<b>CHANGE REQUEST NO. ILC-CR-000N</b>	EDMS No: <b>D0000000xxxxxxx</b>	Created: <b>16-09-2014</b>
		Last modified: <b>24-09-2014</b>

## **DETECTOR HALL WITH VERTICAL SHAFT ACCESS**

Change the underground experimental hall to a design that has a large vertical shaft and allows for the “CMS style” assembly of the detectors.

## **ATTACHEMENT 1.0**

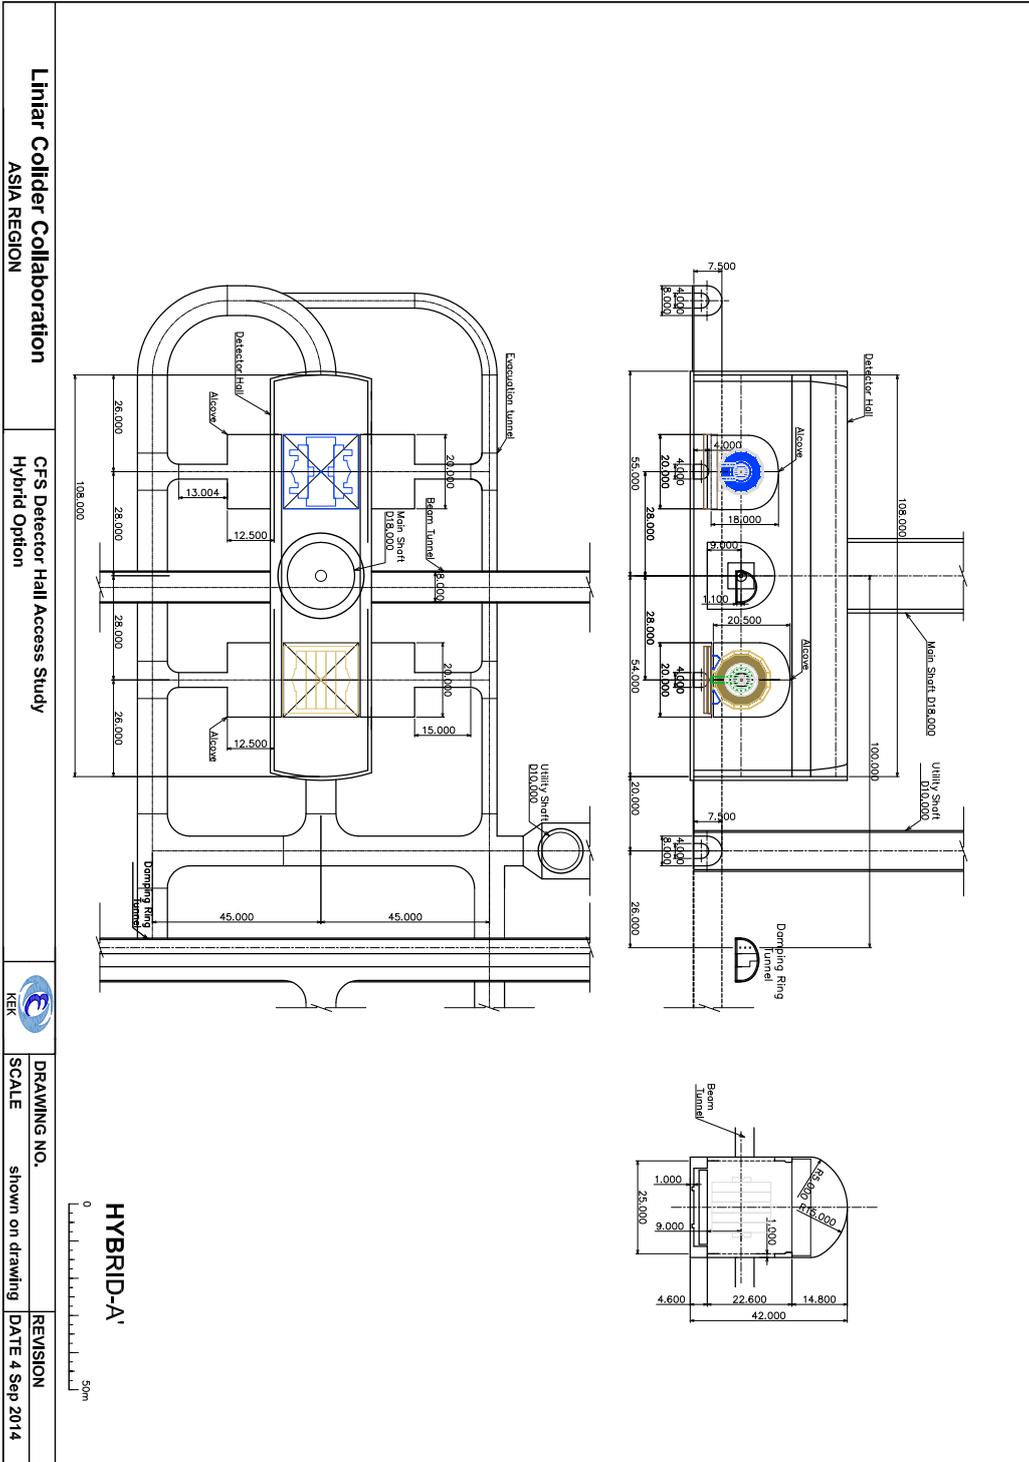
Studies have been performed to find an IR solution with vertical shaft access in the Kitakami region. The proposed design of the underground area is shown in Attachment 1.0. This design has one vertical 18m shaft directly over the interaction point that is used by both detectors for the assembly. The diameter of the shaft is given by the largest detector elements that have to pass it. In addition, services for the detectors (e.g. cryogenics) can be routed through the central shaft. Additional access to the underground area is provided by a service shaft of 10m diameter and by a horizontal tunnel with a width of 8m that mainly serves as access path to the damping rings. The vertical shaft assembly scheme requires sufficient space for assembly buildings on the surface directly above the
